Design Exception #6

Slopes for the Recreational Trail

**I-70 West Vail Pass Safety and
Operations Improvements**

Issue Task Force Design Exceptions Meeting #6

Recreation Trail Design Exceptions

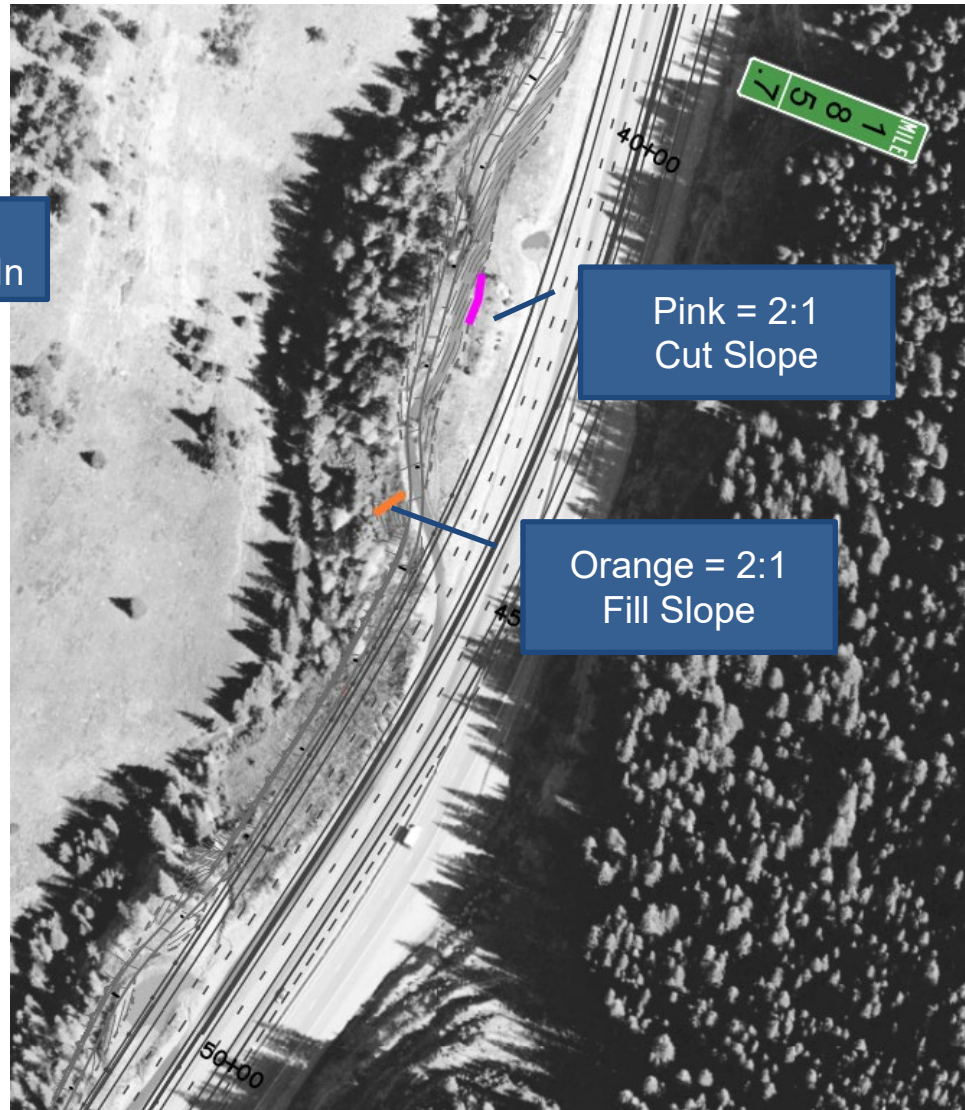
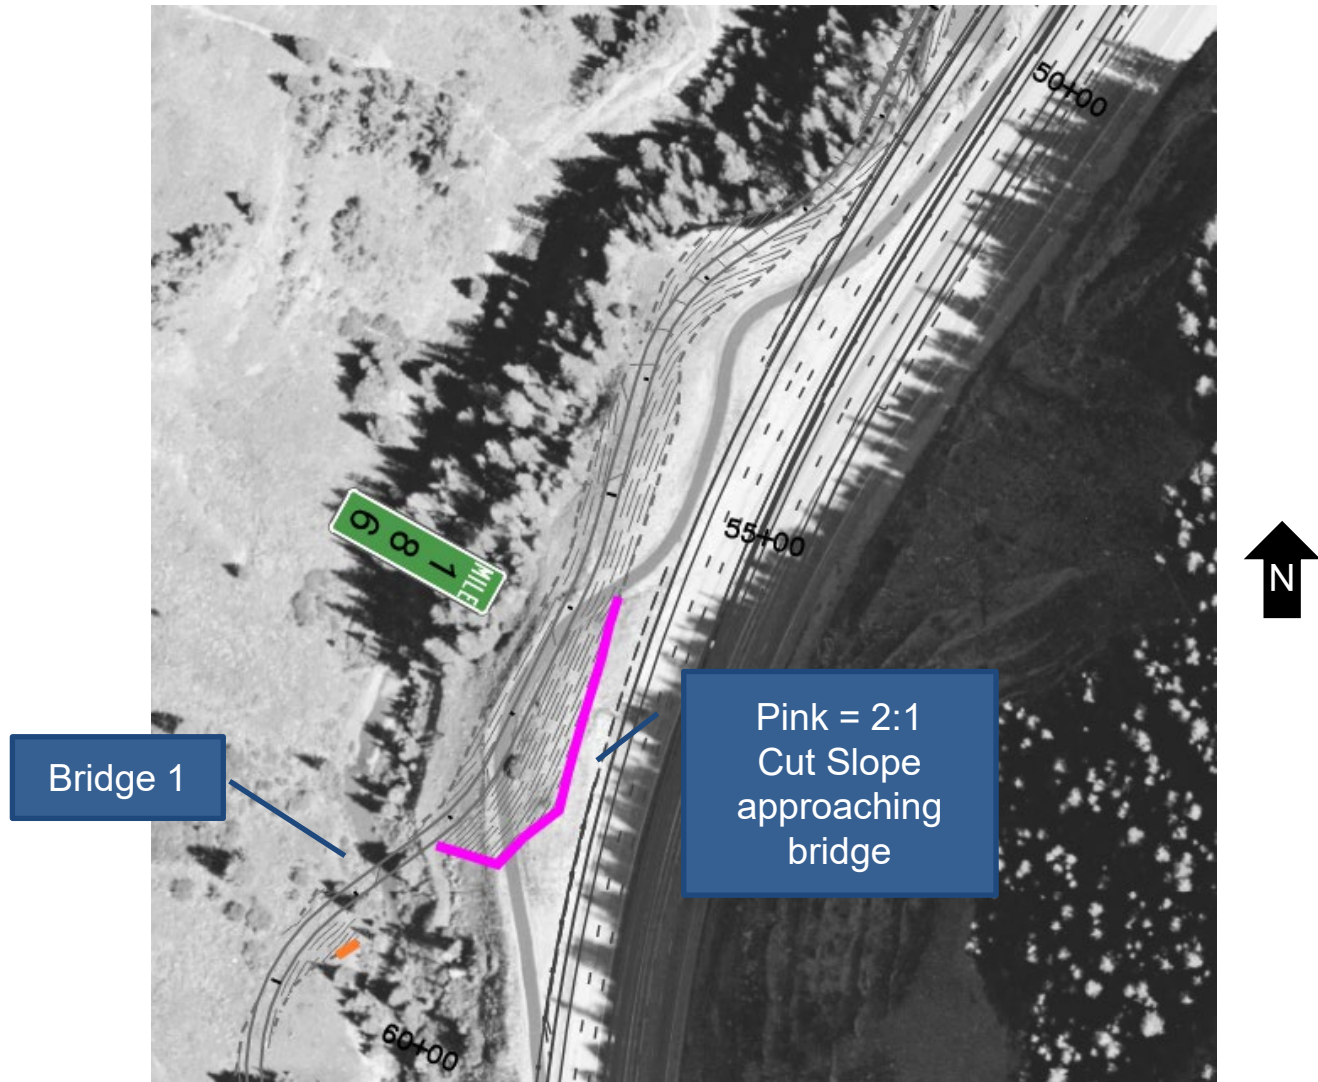
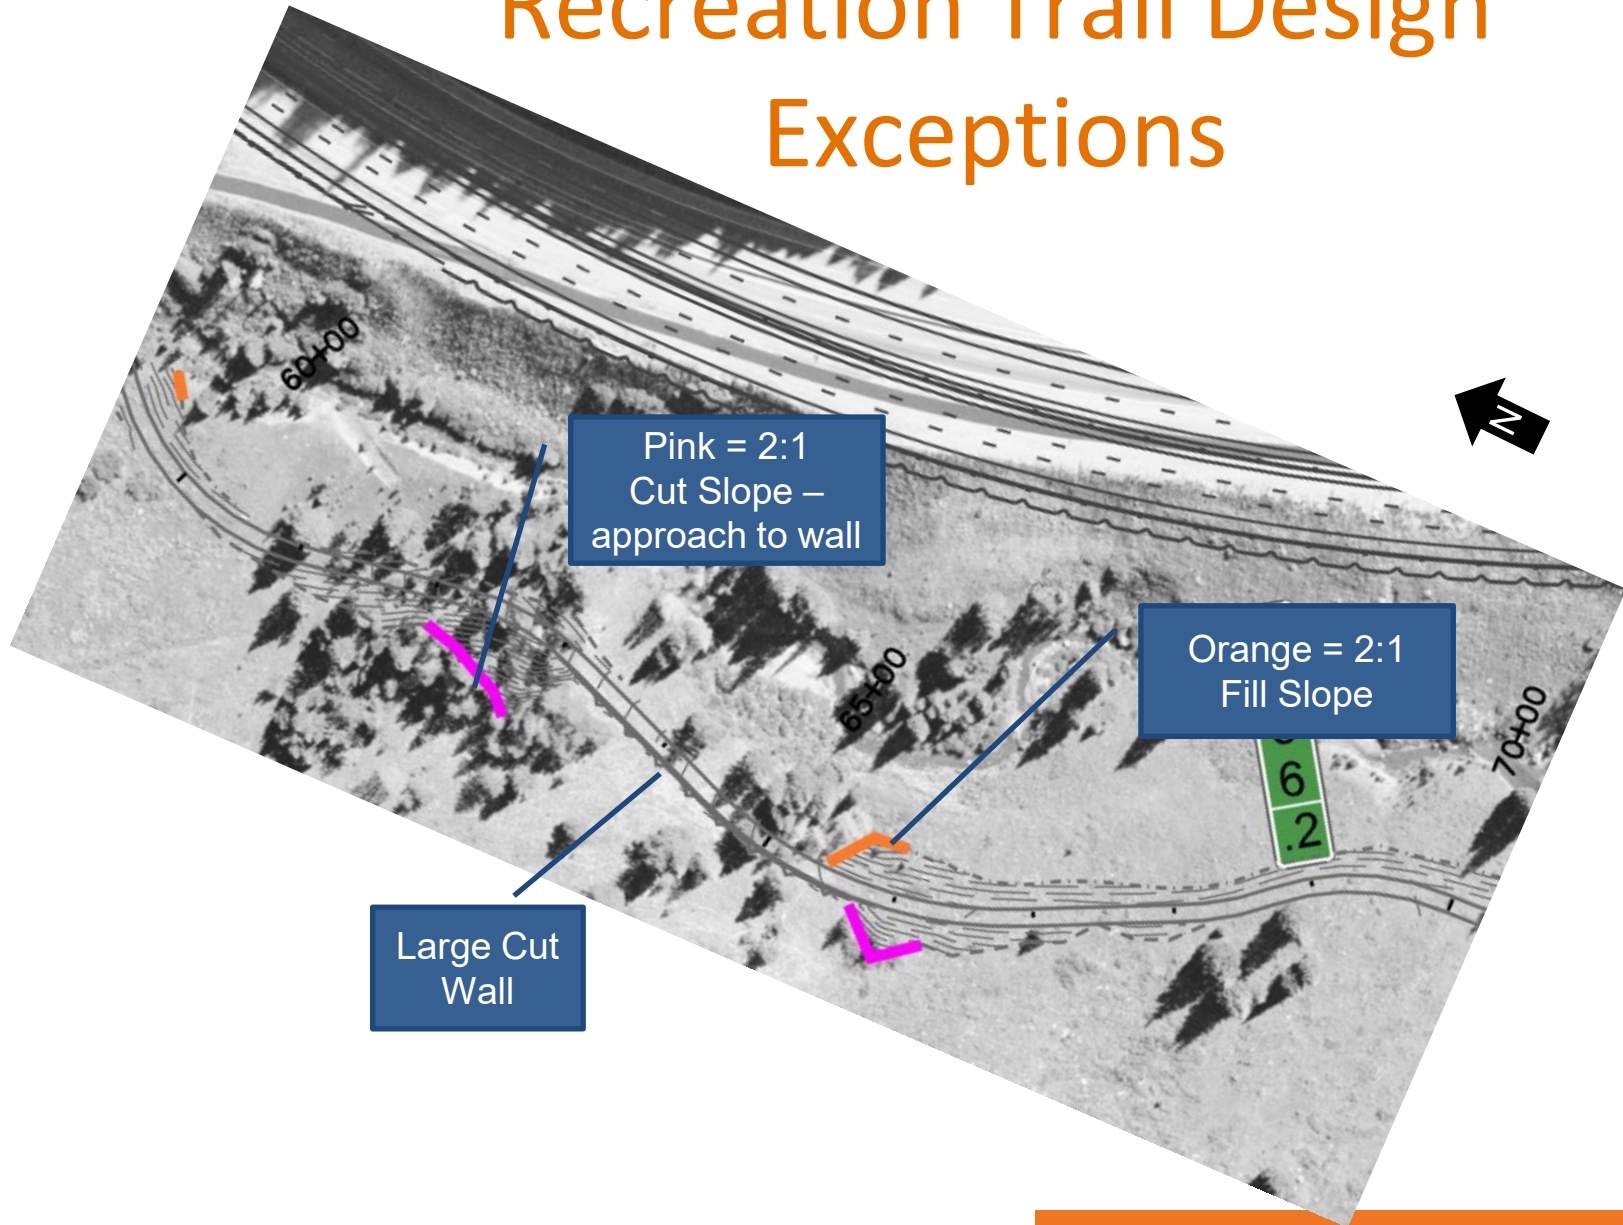
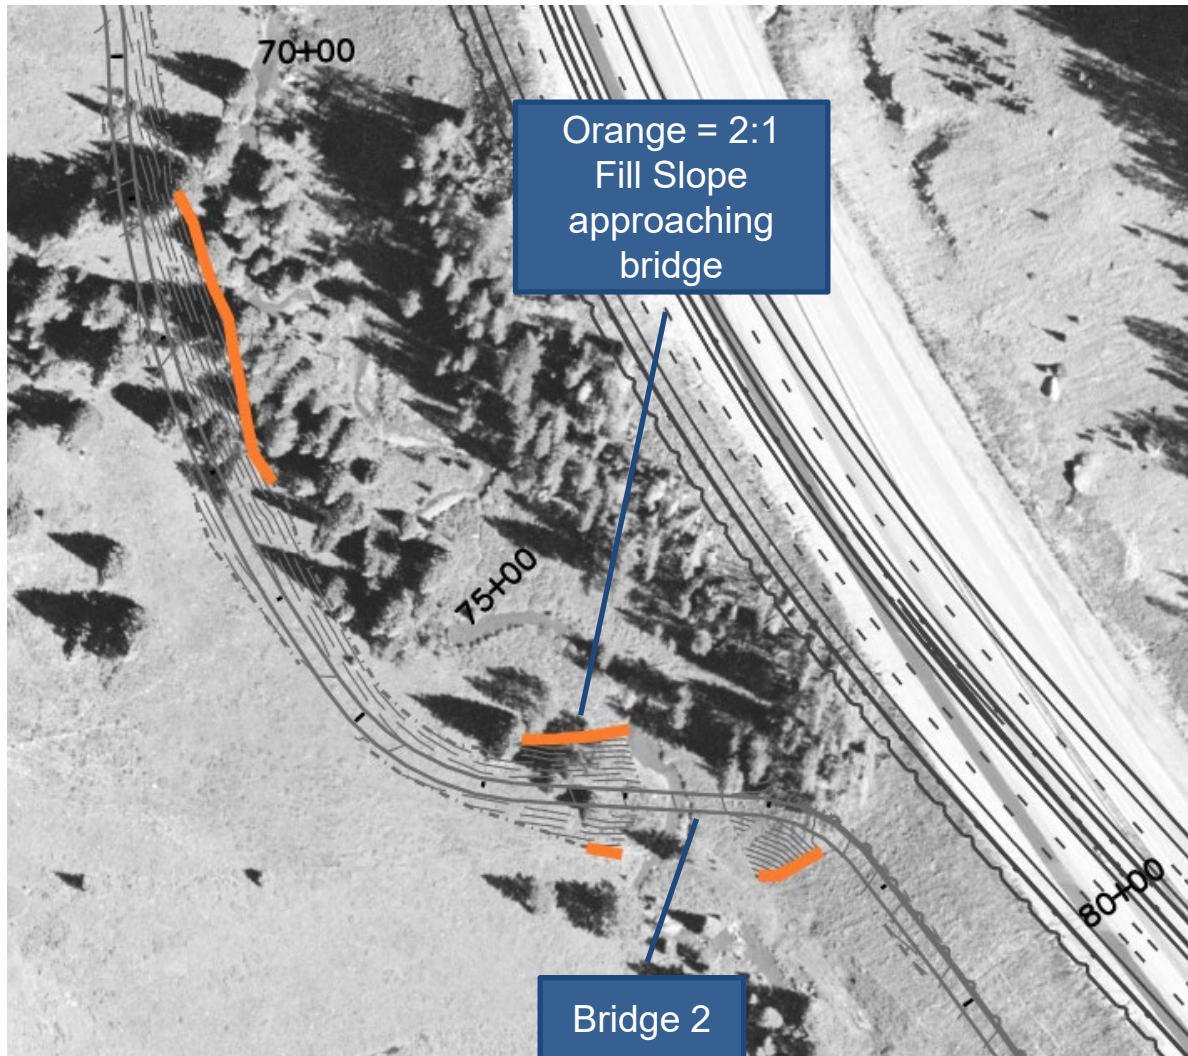
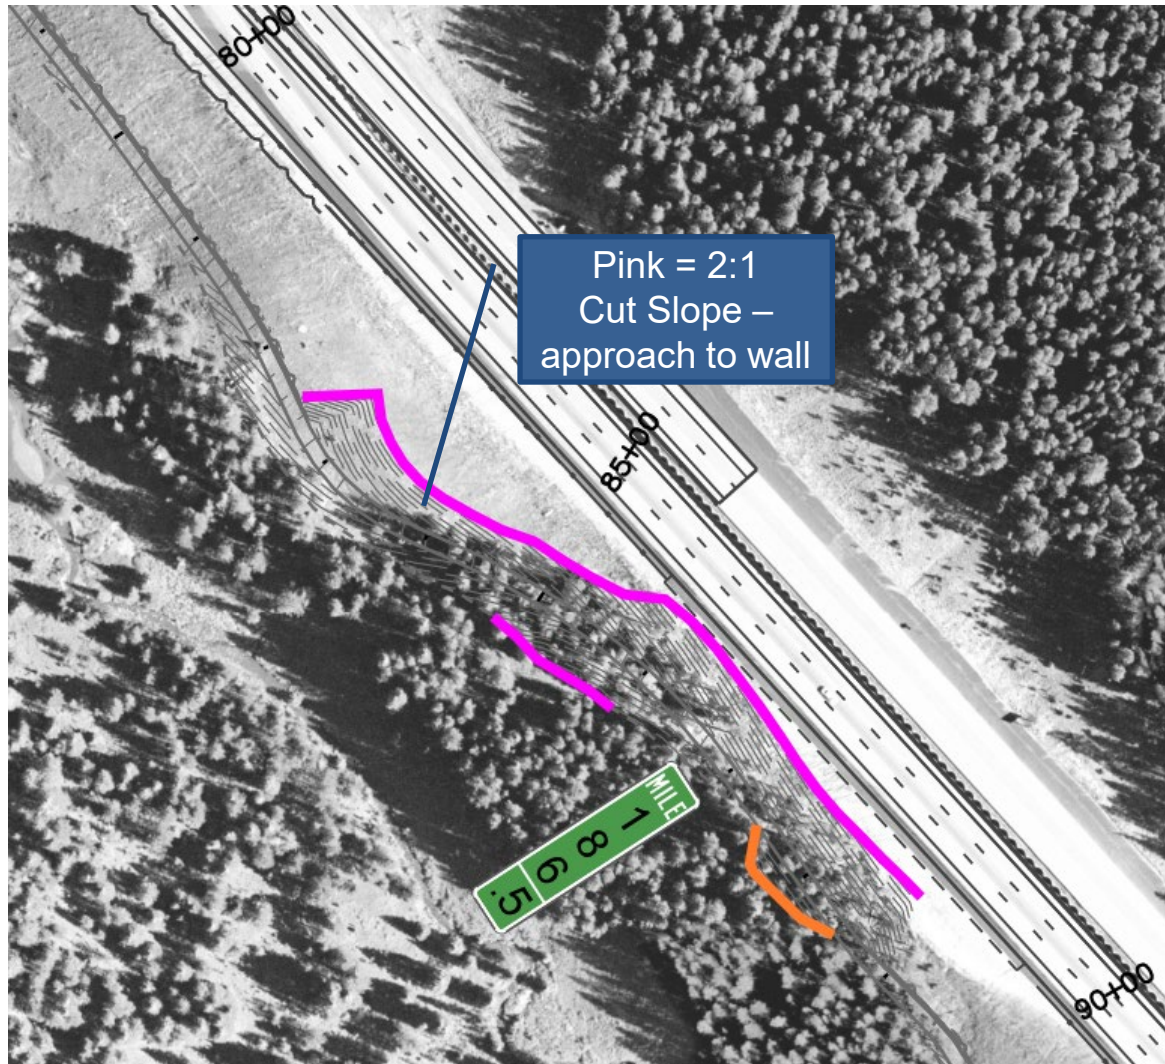
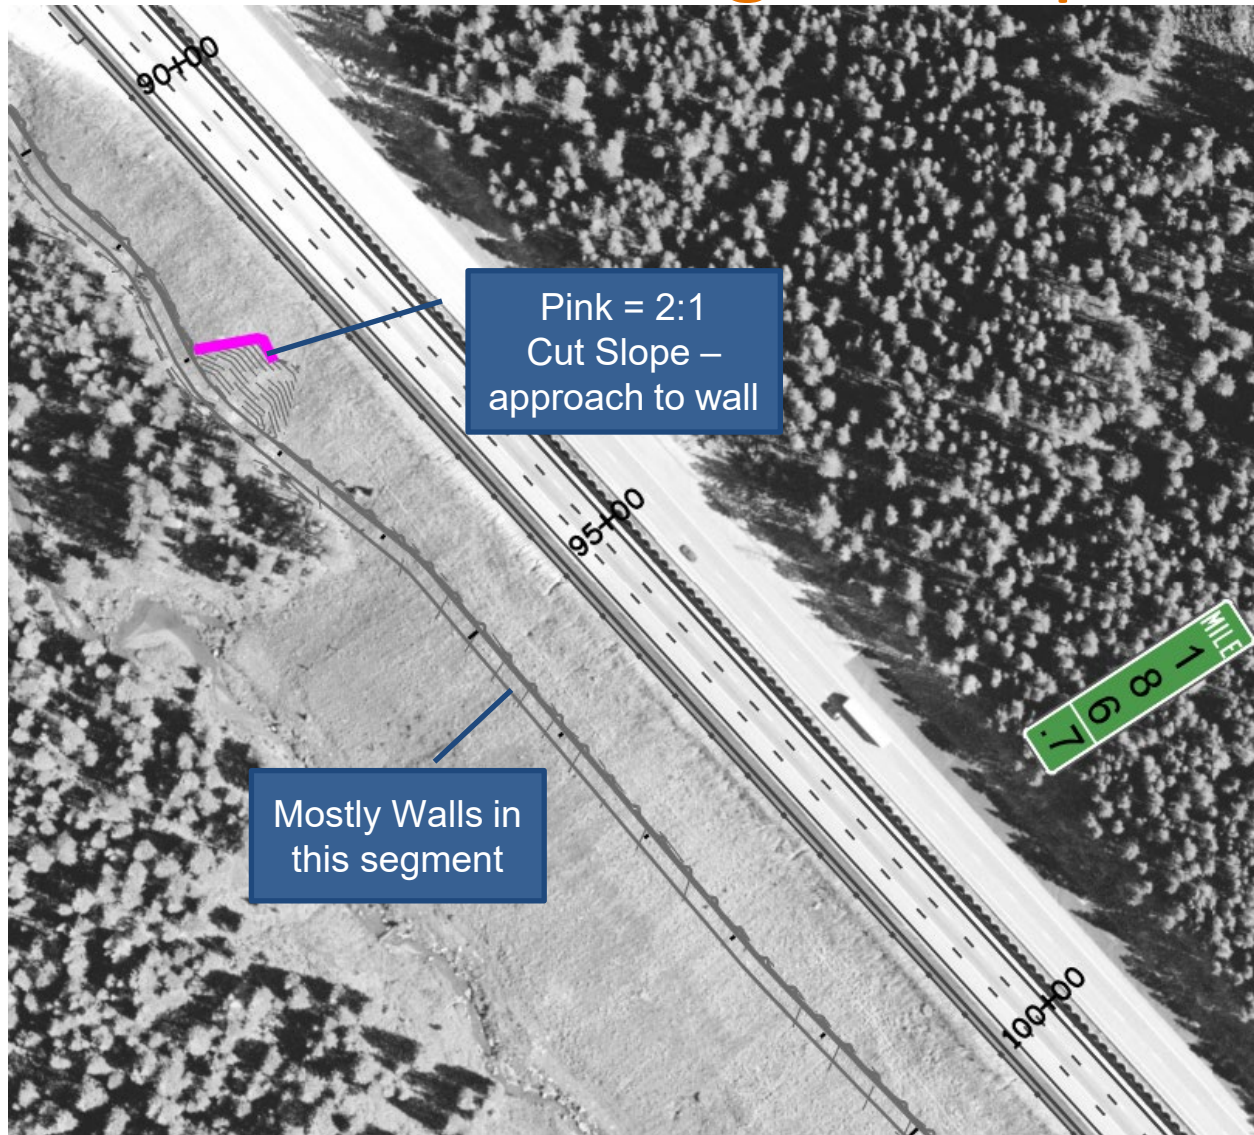
- Approximately 30% of the proposed slopes are 2:1
- Eliminating the 2:1 slopes creates more retaining walls, almost double
- Current 2:1 slopes are primarily approaching walls/ bridges or between the path and I-70

- a) Candice said one of the challenges with the recreation trail is the existing slopes are steep at 2:1. What we found in a quick analyses is that almost 30% of our proposed slopes are 2:1 instead of the preferred 2.5:1. If we don't use a 2:1 slope in the design, our retaining walls almost double. Using 2:1 slopes help keep the cost down quite a bit for the retaining walls. Obviously the walls have the least environmental footprint, but they cost more.

- i) Candice said you might be thinking, why don't you just bring the profile up to eliminate that? We've thought a lot about it ourselves but because of the overall elevation gain from the starting point to the ending point we have some very steep profile grades. We are trying to navigate the existing steep slopes with proposed slopes with retaining walls. Generally, those 2:1 slopes are approaching the retaining walls or bridges. That is where we are proposing to use the 2:1 slopes.

- ii) During our field visit we learned a lot and we will continue to evolve the alignment. In the area approaching Bridge 1 we looked at shifting the alignment a little further down the slope and that allowed some of these 2:1 slopes to be eliminated.

- iii) We've got some cut walls going down towards the creek and others approaching the bridge. Some of the bridge grading will be refined once we get the bridge abutment set and know what the grading all around the abutment and wing walls look like.

- iv) There are also some cut walls between the rec path and I-70 and the 2:1 slope Design Exception allows a slope instead of a retaining wall with some cut instead of walls the entire length. This is another area we looked at in the field that we might be adjusting based on the existing topography.

- v) Candice said there is a long cut wall where we won't have 2:1 slopes. We're just trying to tie into existing hillside and minimize the height of the cut wall.

- vi) 2:1 slopes will be used to stay further away from the highway in some locations. We will use an offset barrier in some locations to make sure we tie in at the barrier locations. The proposed slopes will be used to try to catch the tie in points where we have steep grades.

- i) Greg said the existing slopes from the interstate down, irrigation could be put in to really establish revegetation on the steeper slopes. He has a project that is putting in a lot of temporary irrigation. It seems with summers getting warmer, we can get vegetation to re-establish better on steep slopes with irrigation.

- ii) Greg said that's the hard part when you go to 2:1. You're kind of in a catch 22 situation. You use a steeper slope and put the protection on there but if your seeding doesn't take, it's really hard to reseed it a second time to get it to take. That would be my concern about these design exceptions.

Use slopes ranging from 2.5:1 to 1.8:1 as directed by the project Landscape Architect to create a slope that fits into the adjacent landform, looks natural, sustains vegetation and is maintainable.

Hearing no objections or language change suggestions, Mary Jo said we will move forward with the assumption that everyone is comfortable with these slope design exceptions and with the PLT approval, our designers will move forward using this design exception.
